SP 3-284-001
SERVICE PROGRAM

Transmission Control Module (TCM) Shield.

This Service Program provides information regarding the installation of the Transmission Control Module (TCM) shield on certain model year 2014-2015 Xpeditor vehicles with ISL/ISL-G engines.

Figure 1

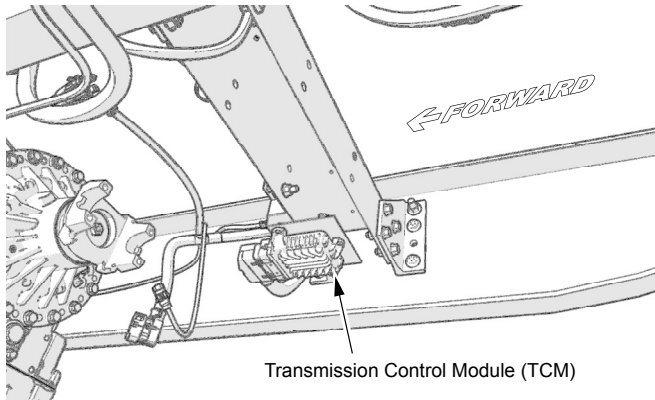
1. Locate the transmission control module (TCM) (see Figure 1).

Figure 2

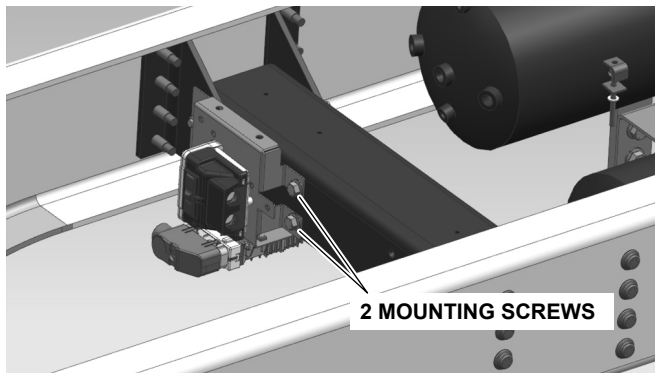
2. Remove two TCM bracket mounting screws and discard (see Figure 2).

Note: If the original hardware is missing or damaged, 3 GE410419CB07 # 10 screws and 3 GE811619NS01 # 10 washers may be used to secure the TCM.

Figure 3

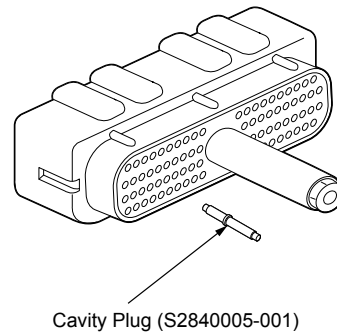
3. Unplug the connector from the TCM and inspect the connector for missing cavity plugs. Replace with cavity plug (S2840005-001) as needed (see Figure 3).

Note: Inspect the cavity plugs and the connector for any evidence of corrosion. If corrosion exists, clean the affected areas using a soft bristle brush and a mild solution of water and baking soda.

Figure 4

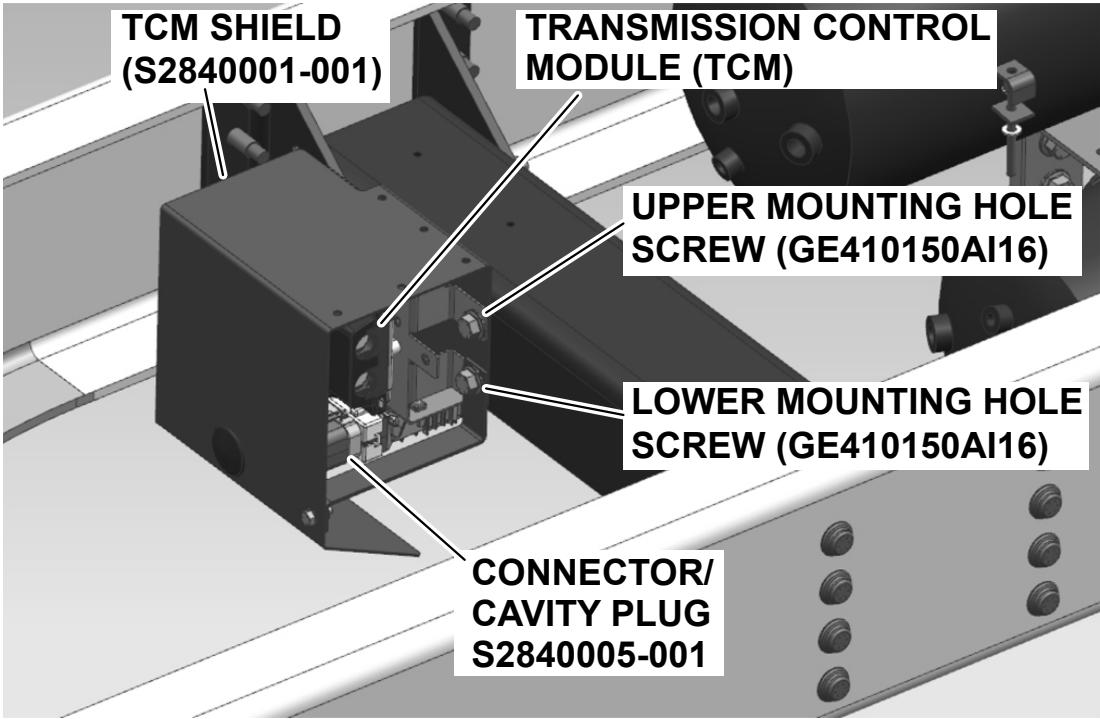
- 5. Install the TCM shield (S2840001-001) by sliding it behind the TCM and installing 1 screw (GE410150AI16) and 1 locknut (GE286250BO01) into the upper mounting hole. Tighten the locknut to 90 ft-lbs (122.0 Nm) of torque (see Figure 4 and Figure 5).

Figure 5

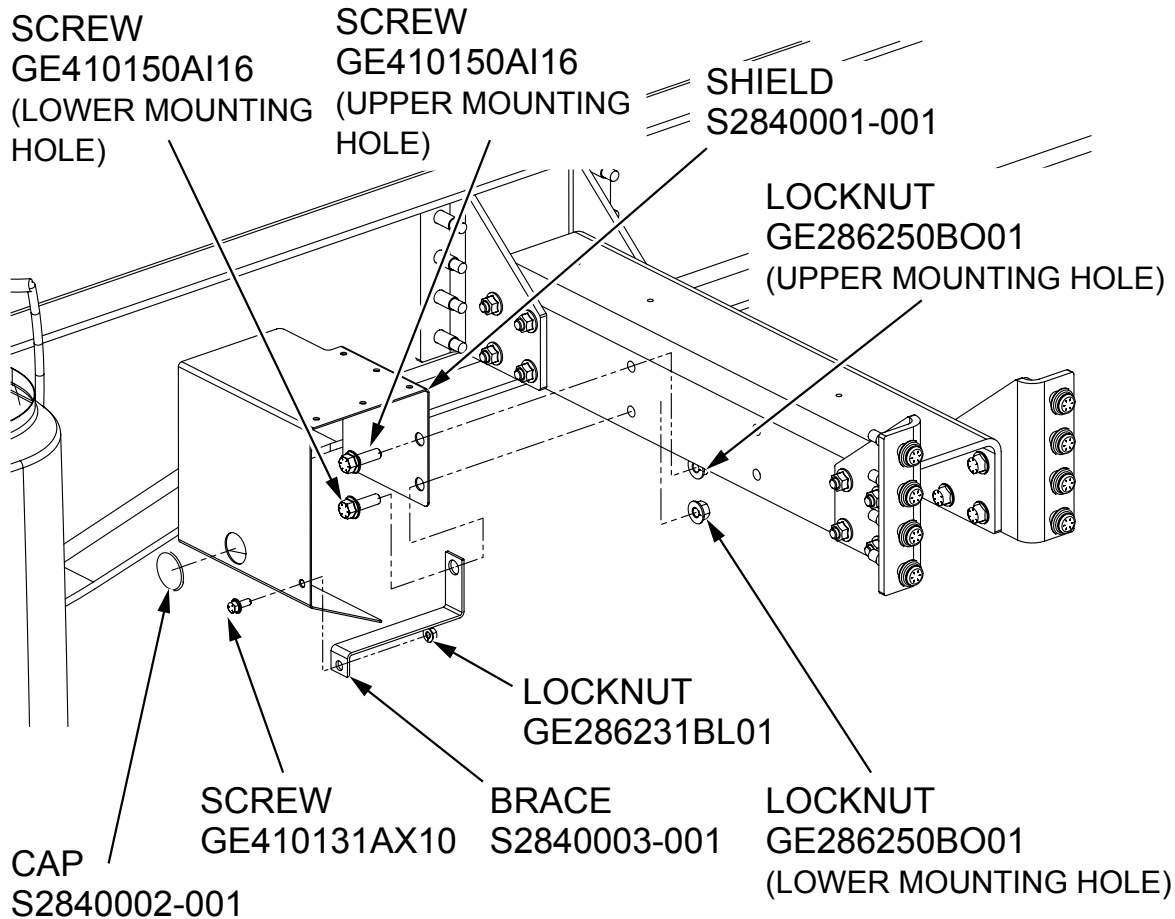
6. Install the TCM shield brace (S2840003-001) with 1 screw (GE410131AX10) and 1 locknut (GE286231BL01) and tighten to 15 ft-lb (20.34 Nm) of torque. Install 1 screw (GE410150AI16) and 1 locknut (GE286250BO01) into the lower mounting hole and tighten the locknut to 90 ft-lbs (122.0 Nm) of torque (see Figure 5).
7. Install the TCM shield cap (S2840002-001) (see Figure 5).
8. Installation of the TCM shield is complete.
